EPC STORMWATER REVIEW COMMENTS
IN ORANGE BOXES WITH BLACK TEXT

GRANDWOOD RANCH

ROAD AND STORM PLANS

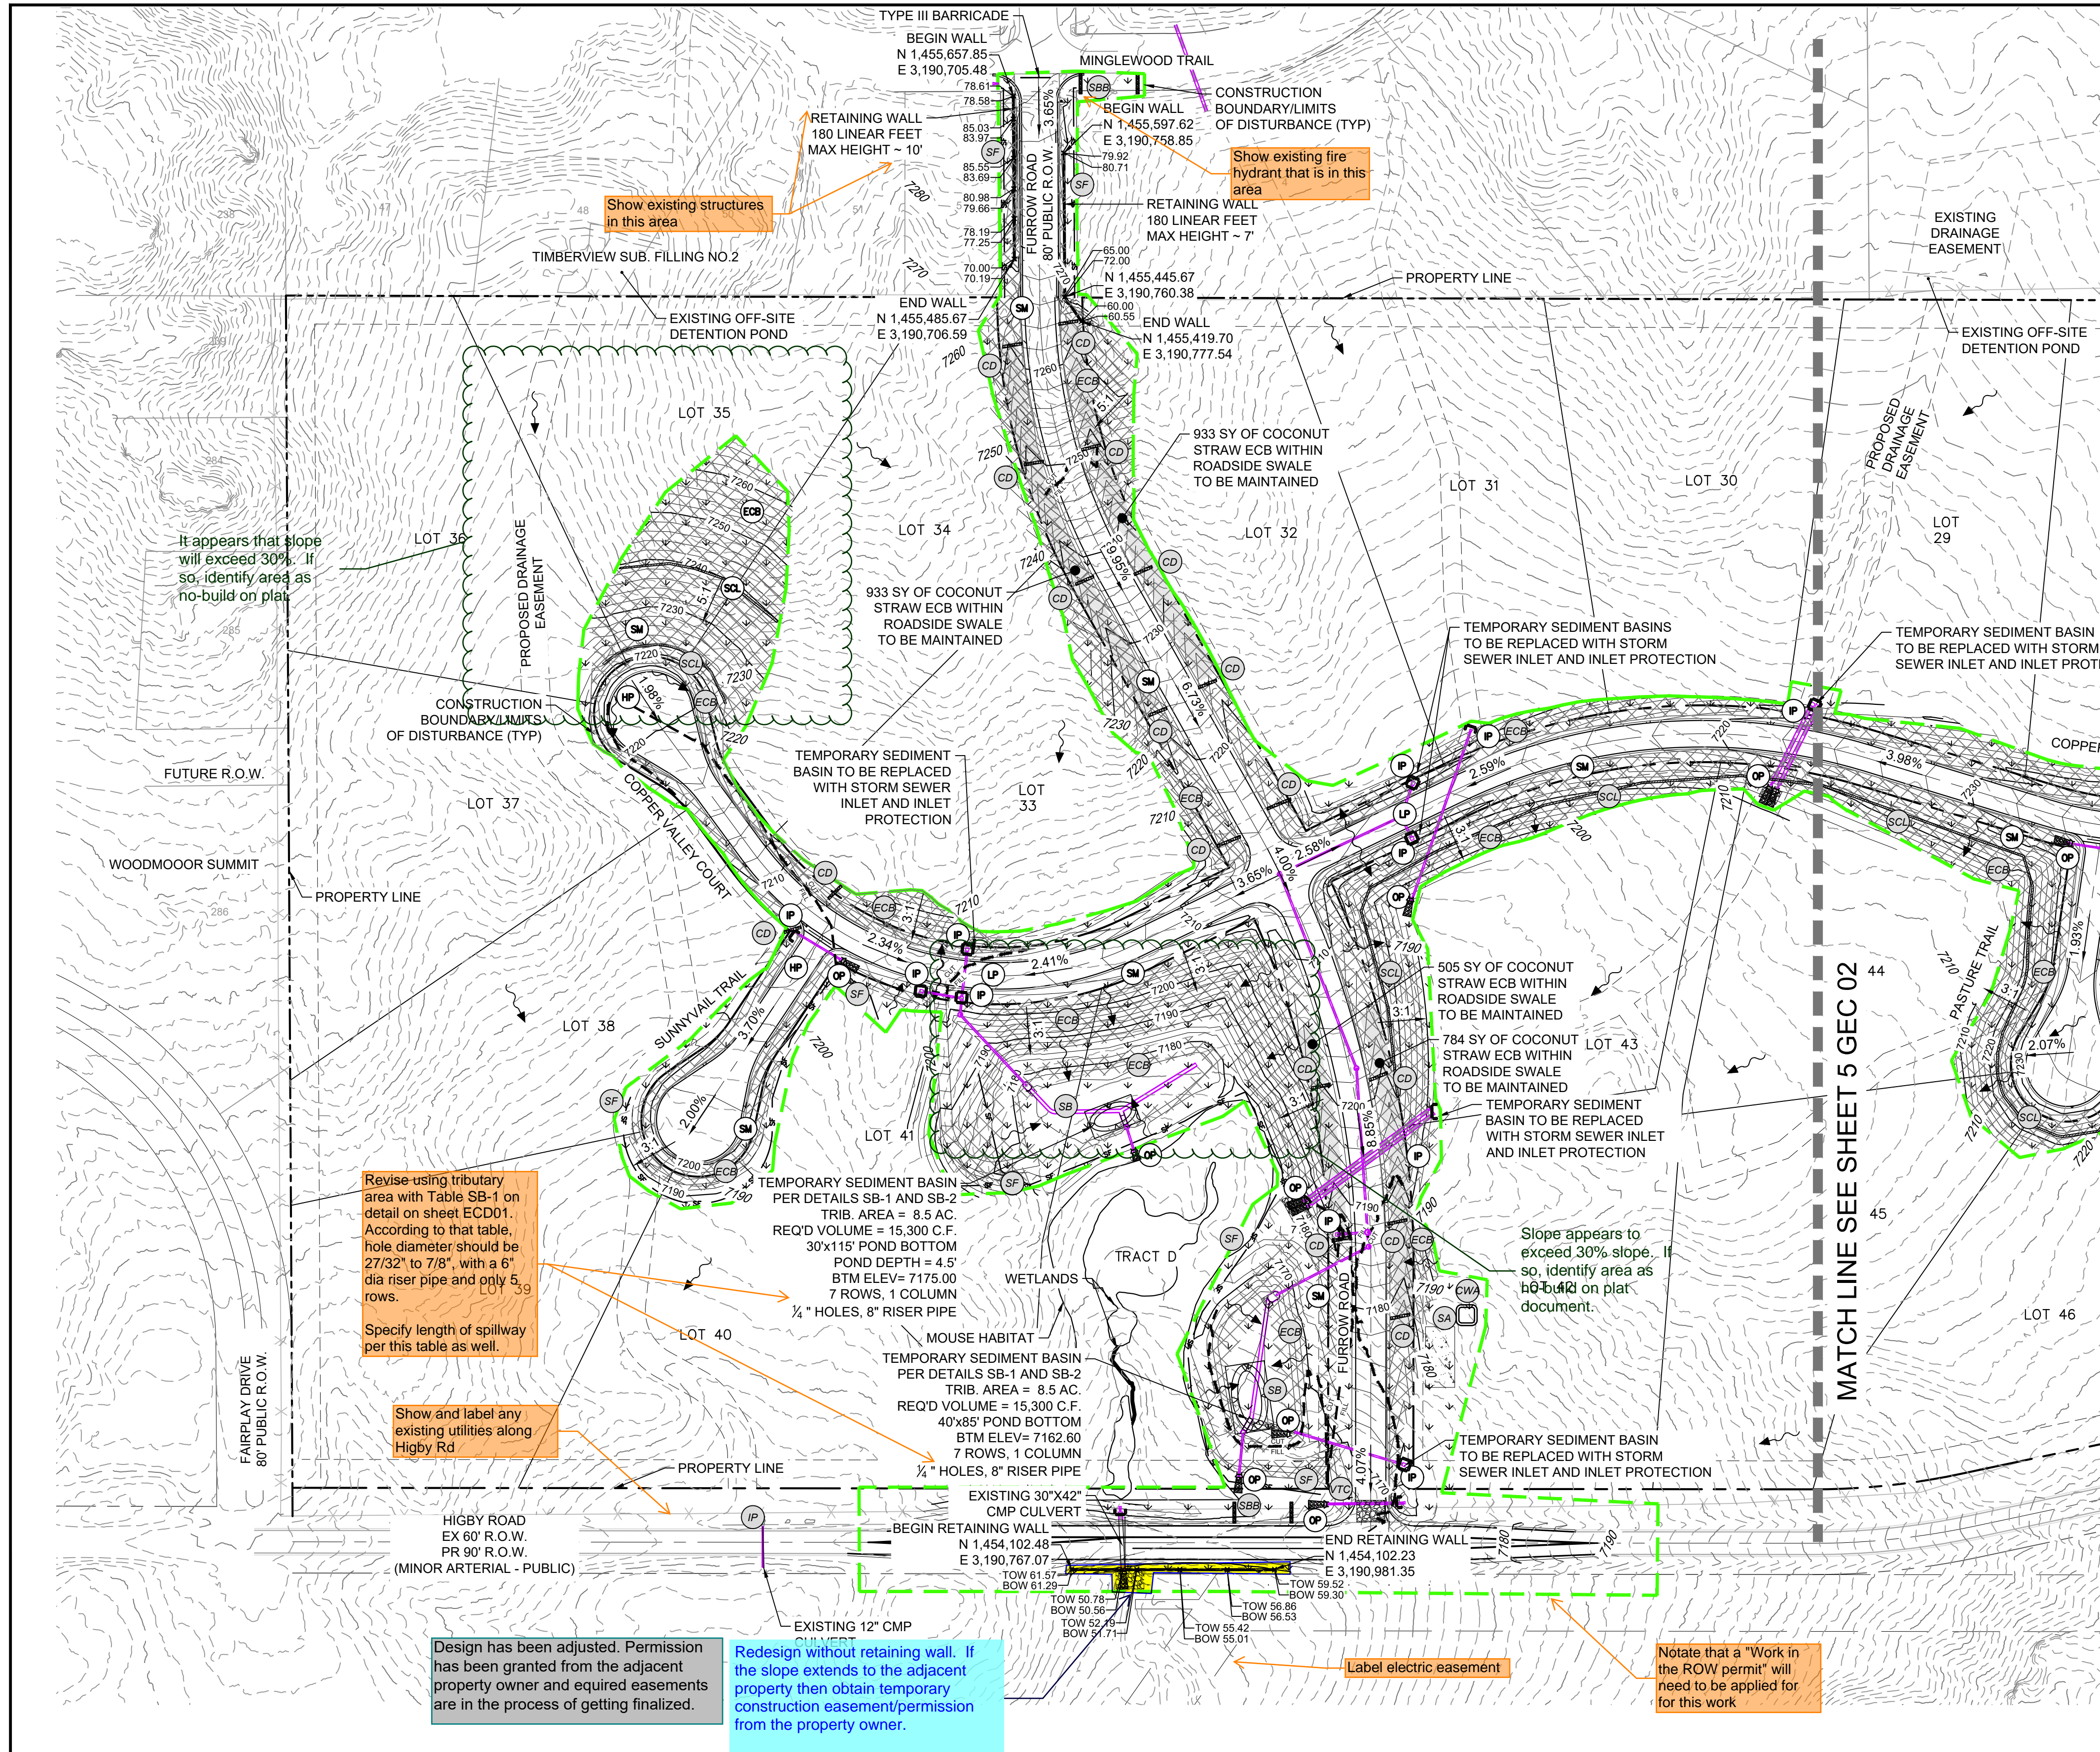
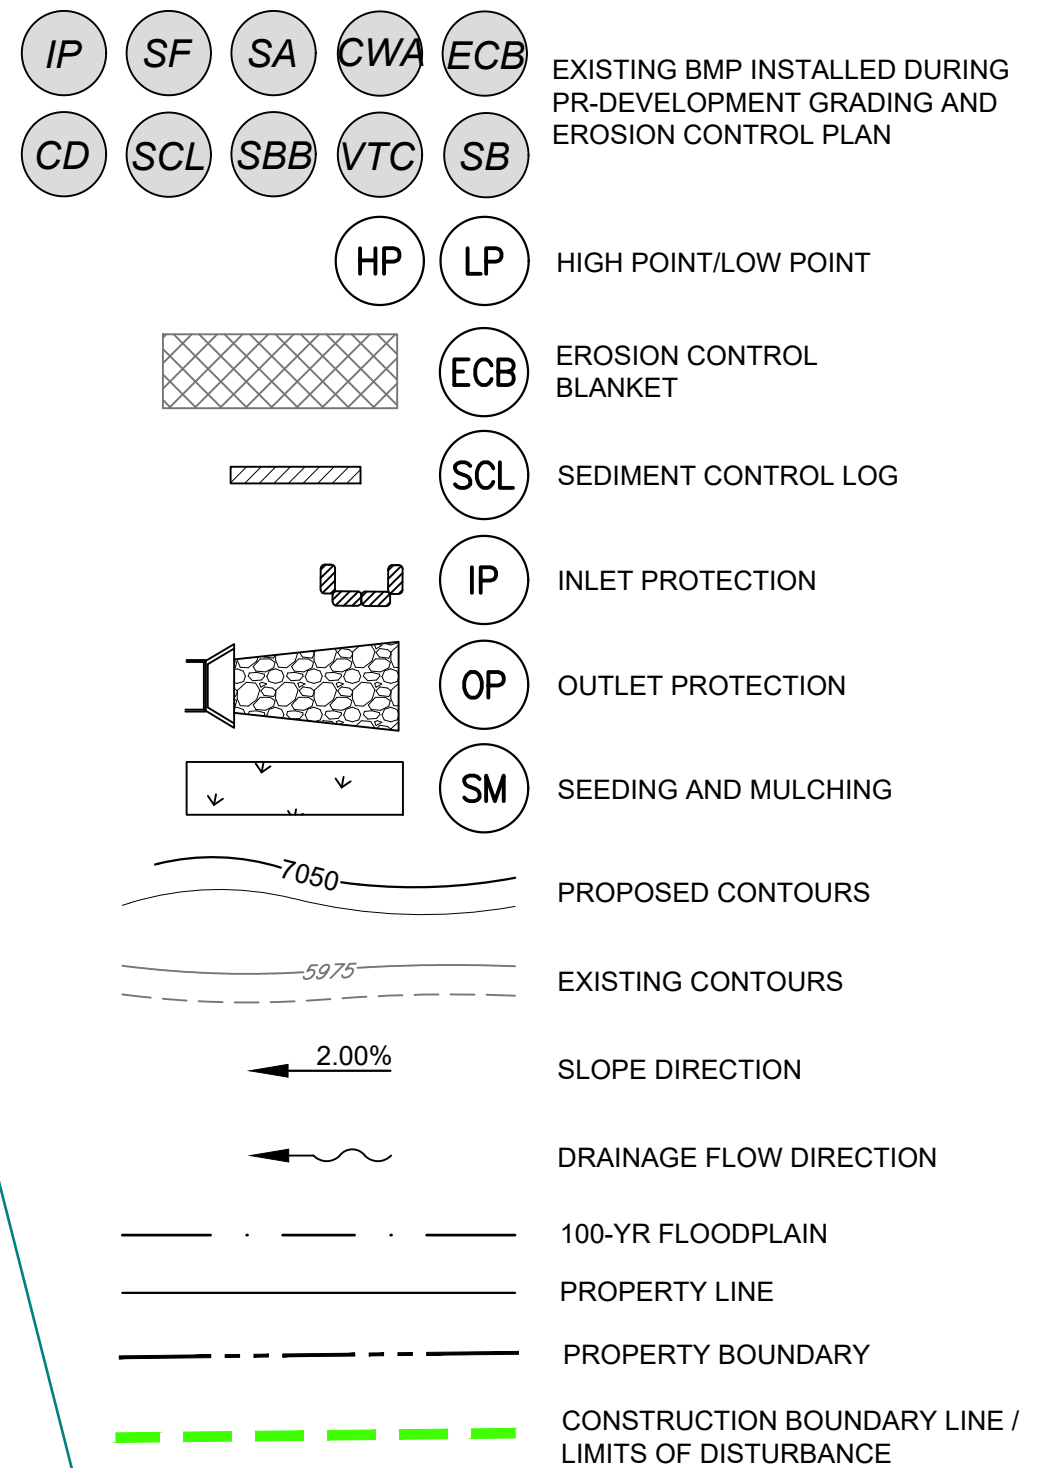
Provide a table identifying proposed BMP's by phase (initial, interim, and final)

Table is provided below
